**ANNUAL GW
MONITORING
REPORT (2)**

Re: **Approval with Modifications**
Annual Ground Water Monitoring Report:
Gallup Refinery 2009
Western Refining Company, Southwest, Inc., Gallup Refinery,
HWB-WRG-10-007
EPA ID # NMD000333211

**RE: APPROVAL WITH MODIFICATIONS
ANNUAL GROUNDWATER MONITORING REPORT:
GALLUP REFINERY 2009
WESTERN REFINING COMPANY, SOUTHWEST, INC., GALLUP REFINERY
HWB-WRG-10-007
EPA ID # NMD000333211**

SITE PLAN

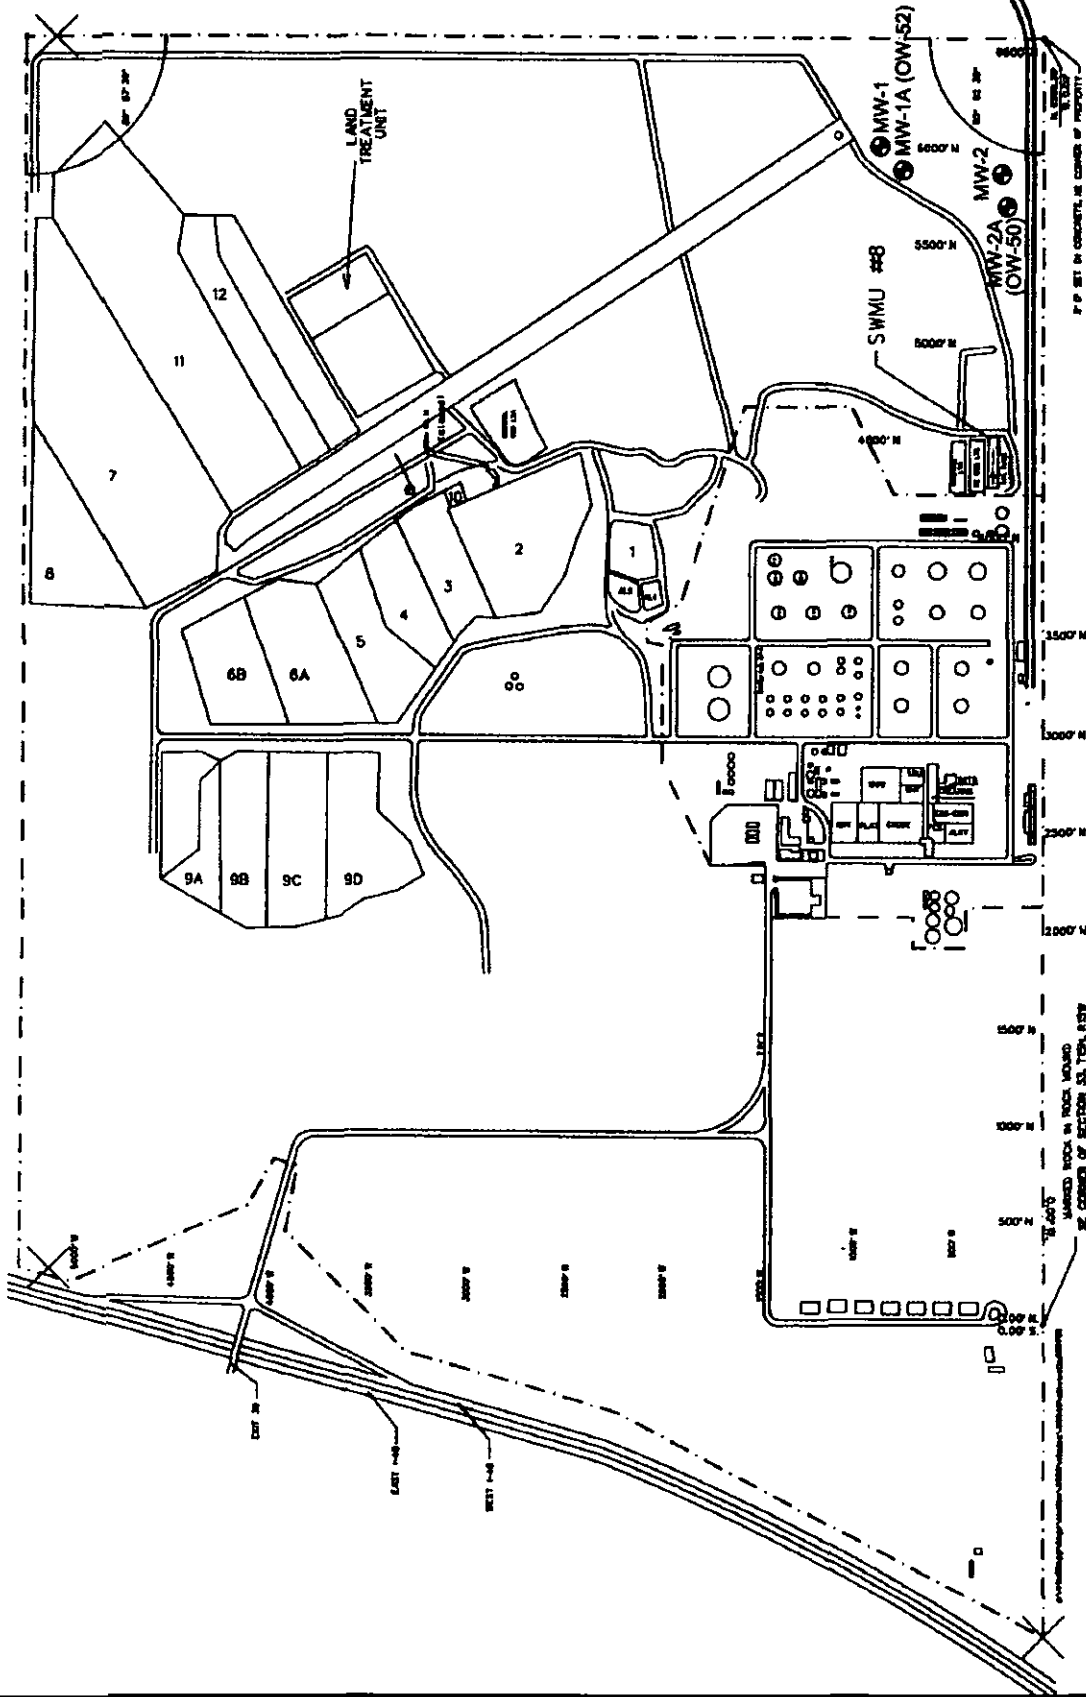
NMED also reviewed the complete version of the New Well Installation Report and determined that the boring log for MW-2A is incomplete. The well construction diagram and the report state that the well was drilled to 63 feet but the boring log stops at 50 feet. Revise the boring log for MW-2A and submit a replacement page for the revised boring log.

Western received Approval with Modifications of the New Well Installation Report from NMED on June 4, 2010 and no reference was made regarding MW-2A boring log as incomplete or revising report to cross reference MW-2A and MW-1A to the correct well identification of OW-50 and OW-52 throughout the report. The Letter Report from AMEC has been revised to incorporate OW-50 and OW-52 as the designated well identifications. The revised report is included as *Attachment 2*.

Figure 1
Monitoring Well Location
Monitoring well locations are at

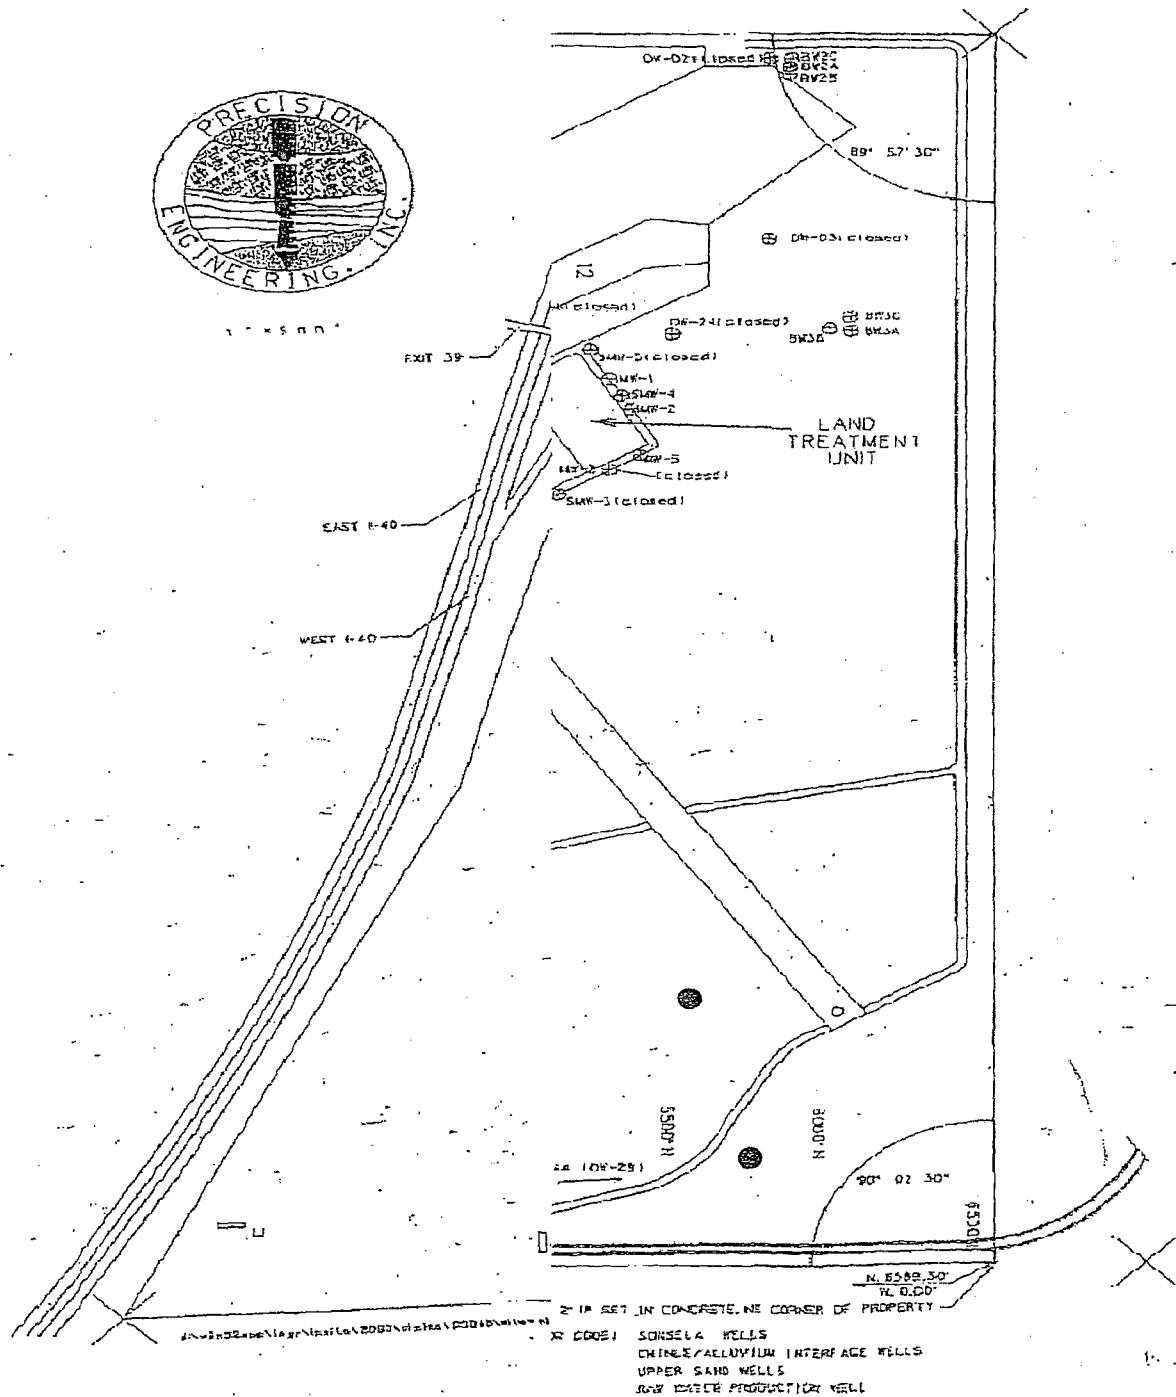
- a. The Permittee must locate the extension of the sand/gravel water bearing layer that extends north of OW-29 and install one monitoring well at the approximate location specified in the attached Figure 1.

FIGURE 2

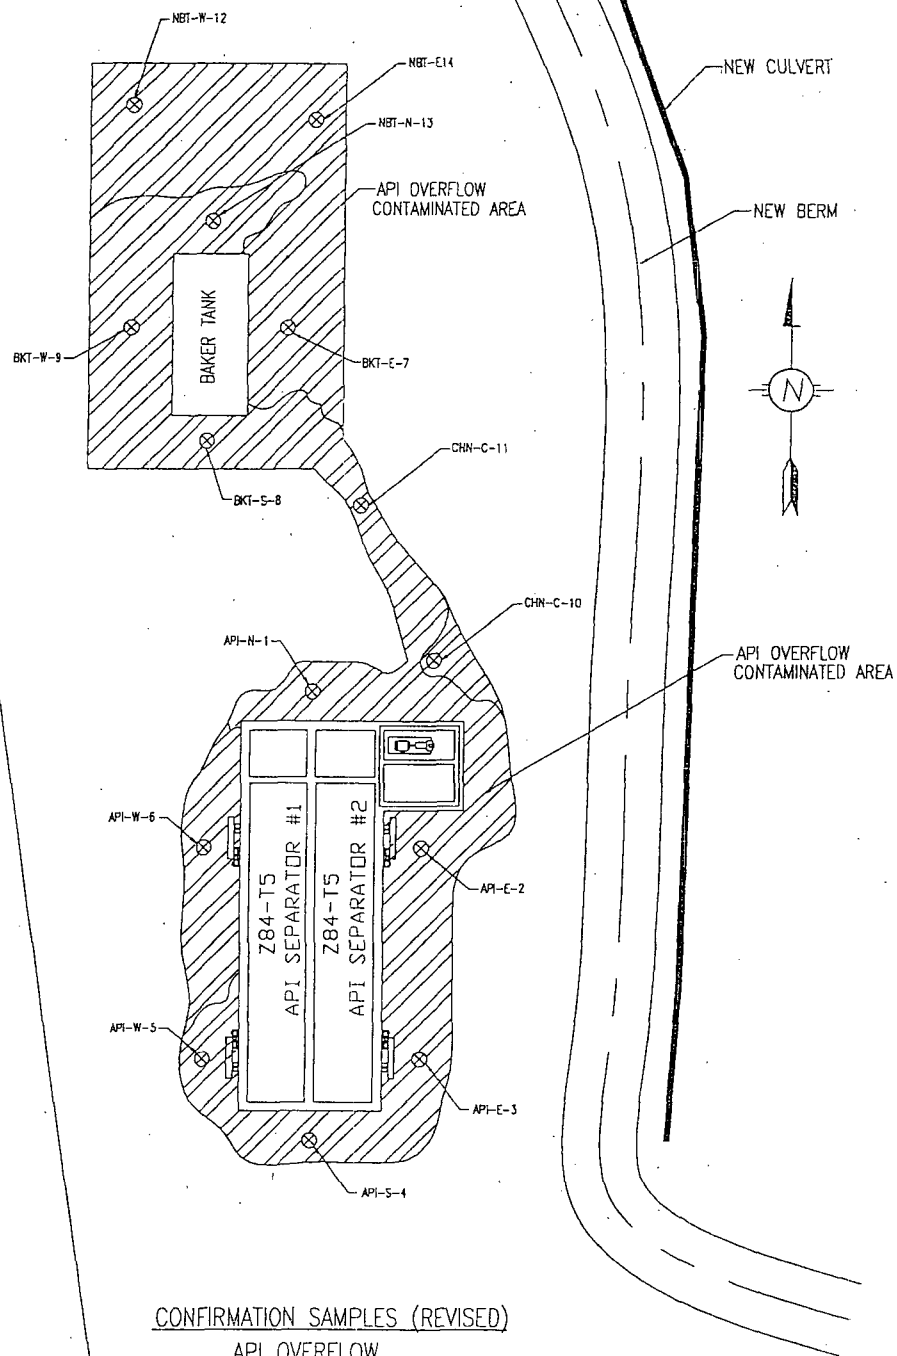
RESPONSE: The facility is in process of addressing the API overflow issue which is the cause of the contamination. An "Interim Measures Work Plan" is being submitted along with this report. This plan addresses the API overflow issues in more detail. Additional excavation and sampling will be conducted around the API and Baker Tanks both under the "BLUE" and "RED" hatch areas. (Figure 2)
